THE VILLAGE AT SQUAW VALLEY JANUARY 2014 SPECIFIC PLAN SUMMARY OF CHANGES

January 10, 2014 Squaw Valley Real Estate, LLC

MOST NOTABLE CHANGES IN PLAN:

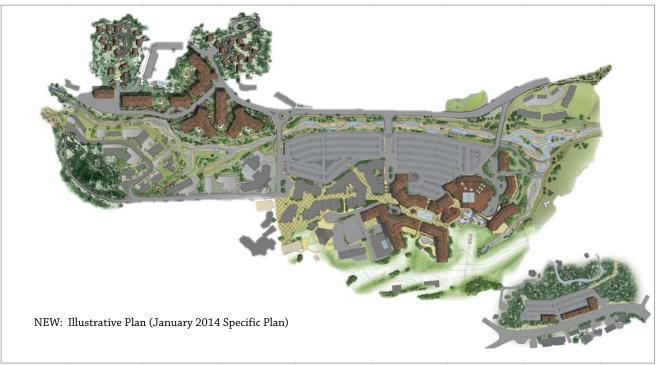
- Overall project reduced by approximately one-third; unit counts dropped from 1093 to 750 and bedrooms, from 2148 to 1493.
- "East Parcel" (formerly Lot 4) is now included in the Project Plan area

- Mountain Adventure Camp (formerly known as Grand Camp) has been reconfigured and the size reduced.
- The former proposed buildings A and O have been abandoned from the plan.

- Day skier parking lots have been retained
- Maintenance and skier services have been distributed throughout the resort and will no longer be housed in one all-encompassing facility (formerly building F).

- All buildings, excluding the Fractional Cabins, have been thoughtfully reconfigured to preserve views.
- The Members Locker facility will be retained in the current building.

- Chamonix Place has been rerouted.
- A Transit Center has been included.
- Shipping/Receiving facility has been relocated to "East Parcel"
- All Building references have changed from letters (i.e. A, B, C, D...) to numbers (i.e. 1, 2, 3, 4...) to conform to more traditional planning references.

- Project Boundaries have been reconfigured to accommodate the new plan. The Plan Area is now approximately 85 acres in size (exclusive of the 8.8-acre East Parcel), with most development still occurring within areas that have previously been disturbed and/or developed.

- Olympic Valley Park has been abandoned from the plan.
- Zoning Designations have been simplified and Land Use Plan has adjusted to accommodate new plan.

LAND USE & ZONING - CHANGES

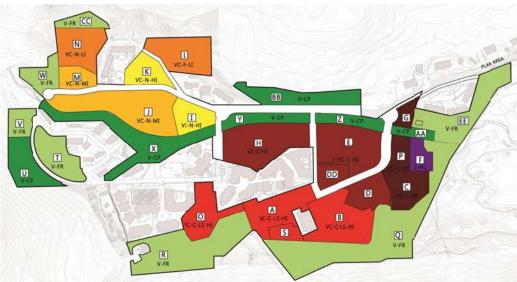
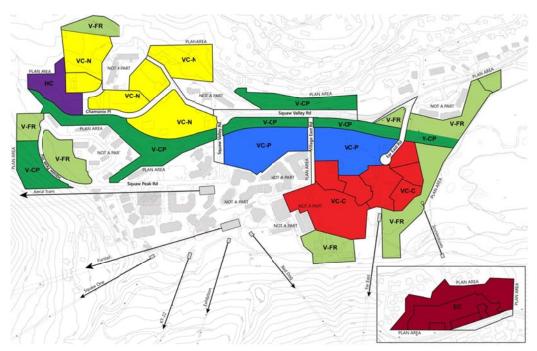
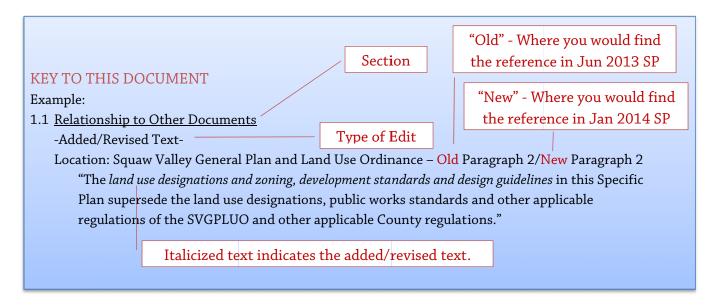
OLD: Land Use and Zoning (June 2013 Specific Plan)

NEW: Land Use and Zoning (January 2014 Specific Plan)
